## SCIENCE, TECHNOLOGY AND GLOBAL SECURITY WORKING GROUP

August 20, 2012

We are writing to call your attention to serious errors in a letter dated April 30, 2012 sent to your Subcommittee by the National Academy of Sciences. The letter reports findings from a National Academy of Sciences (NAS) study titled *Making Sense of Ballistic Missile Defense: An Assessment of Concepts and Systems for U.S. Boost-Phase Missile Defense in Comparison to Other Alternatives*. The errors in the letter stem from miscalculations of radar ranges, that in turn lead to serious errors in the study's findings and recommendations. The source of these errors in radar-range estimates are described by us in an attached appendix and can easily be verified by independent technical experts. There are also other basic errors in the Academy's reported findings which we point to in an annotated version of the April 30 letter also attached as an appendix to this letter.

Figure Caption:

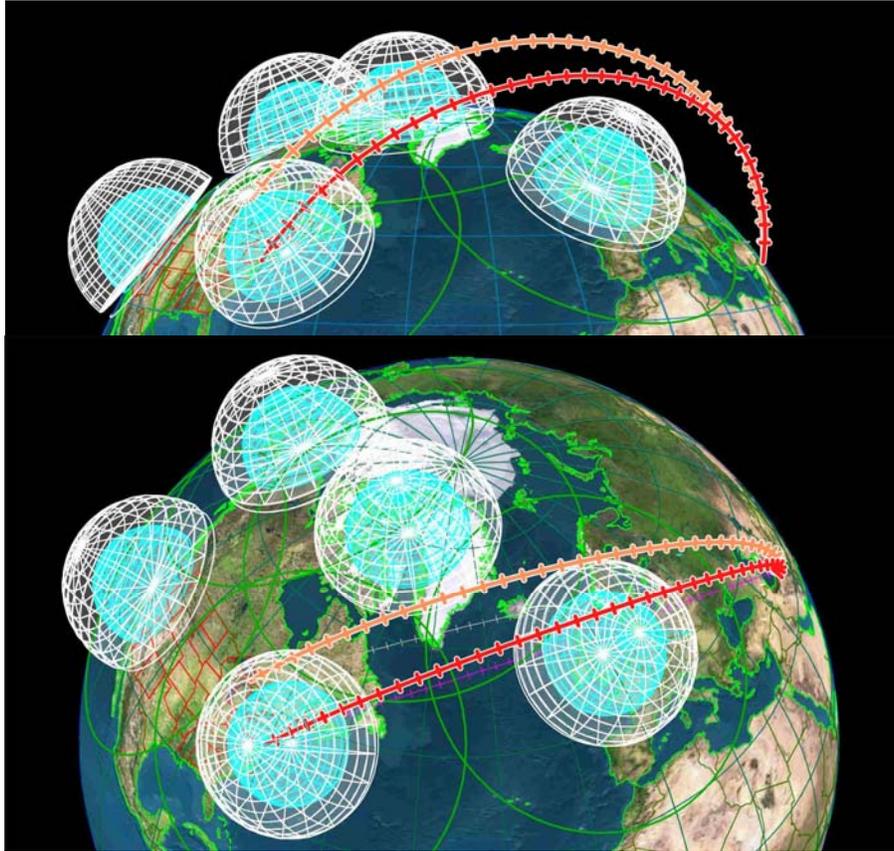
Two views of the range capabilities provided by the new X-band radars proposed by the NAS study against Iranian ICBMs on slightly lofted trajectories. The outer hemispheres shows the ranges at which these radars would be able to begin tracking the warhead, as documented in Appendix 3. Note that the existing Early Warning Radars at these sites already provide much greater tracking ranges, as shown by the light-green circles. The inner blue hemispheres show the range at which the new proposed X-band radars would begin to have sufficient signal-to-noise to attempt to perform discrimination.
